## Subdivision & Land Development Notice Plan Review LD-18-03

**RE: Land Development Application LD-18-03, 1768 Kimball Avenue, Willow Grove, PA 19090 - Popper & Deacon, Inc.**

RE: 1768 Kimball Avenue (Parcel # 300036264003) - Sanitary Sewer Review

4" LATERAL CONNECTION TO  
AN EXISTING SANITARY MANHOLE

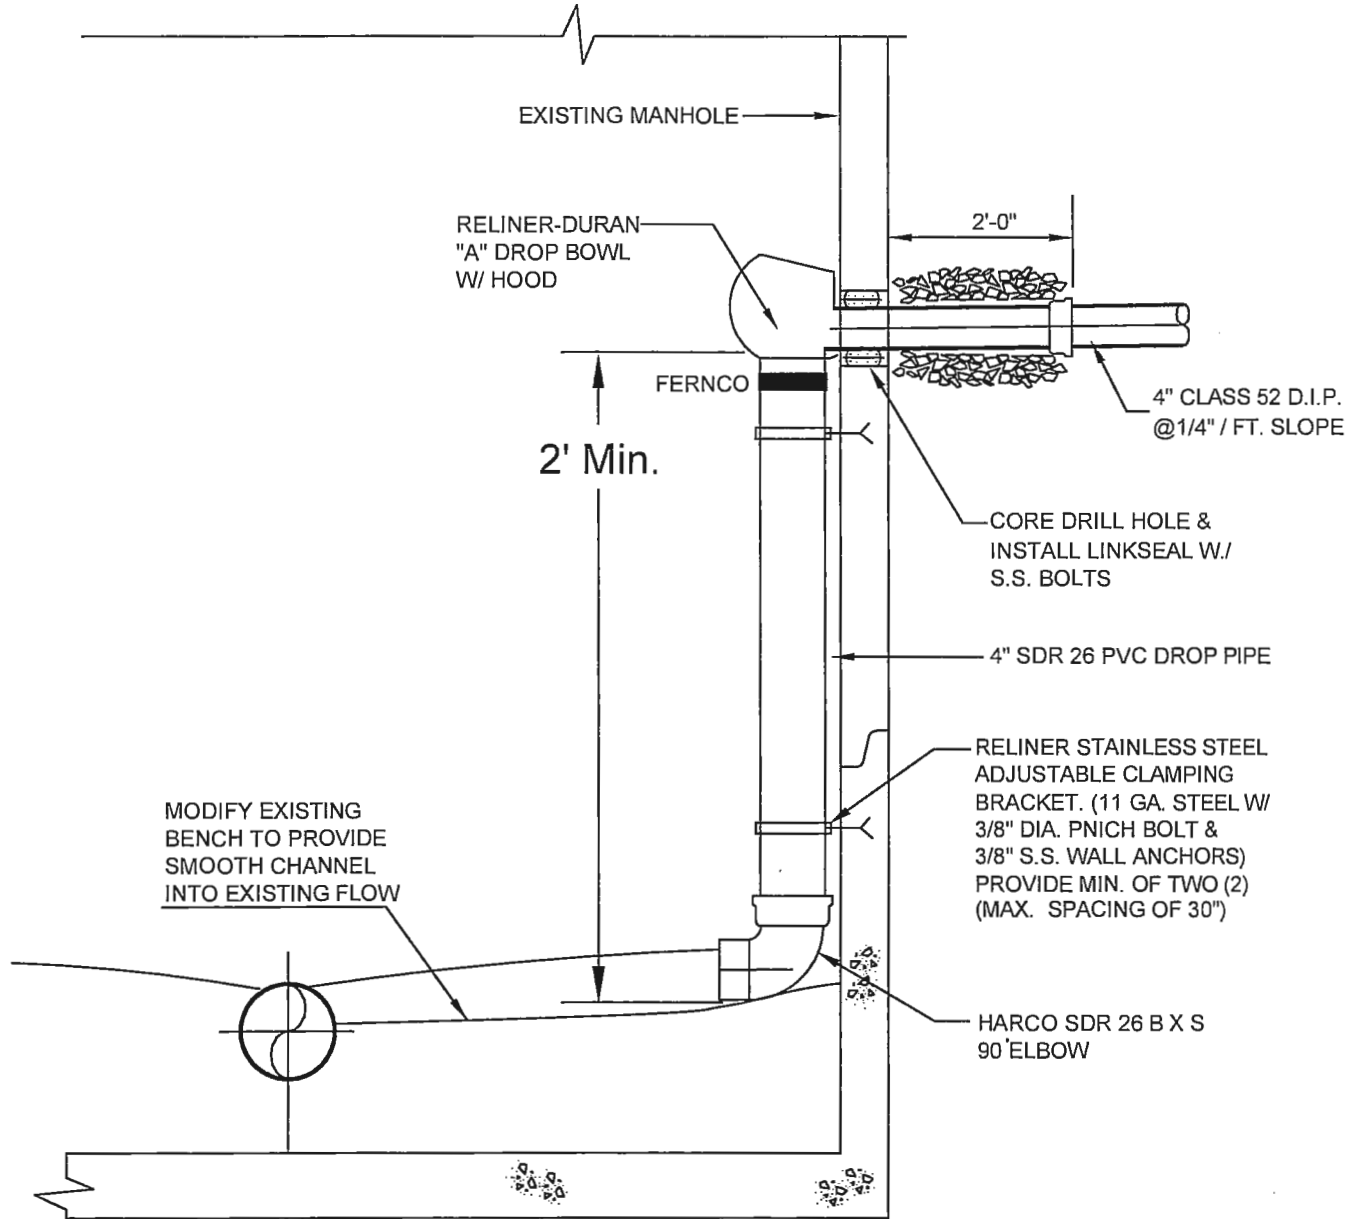
Sheet 3 of 4 - The proposed sewer line for Lot No. 2 should not connect into the sanitary sewer main in Kimball Avenue. The lateral sewer shall be connected directly into the existing Manhole No.1913F. (See enclosed construction detail). The size of the pipe is not required to be 6" and should conform to the requirements of the Plumbing Code. (The pipe material shall be Ductile Iron Pipe within the road Right-of-Way)

Sheet 3 of 4 - The proposed sewer line for Lot No. 3 should not connect into the sanitary sewer main in Kimball Avenue. The lateral sewer shall be connected directly into the existing Manhole No.5196 located in Windsor Avenue. (See enclosed construction details. The pipe material shall be Ductile Iron Pipe within the road Right-of-Way)
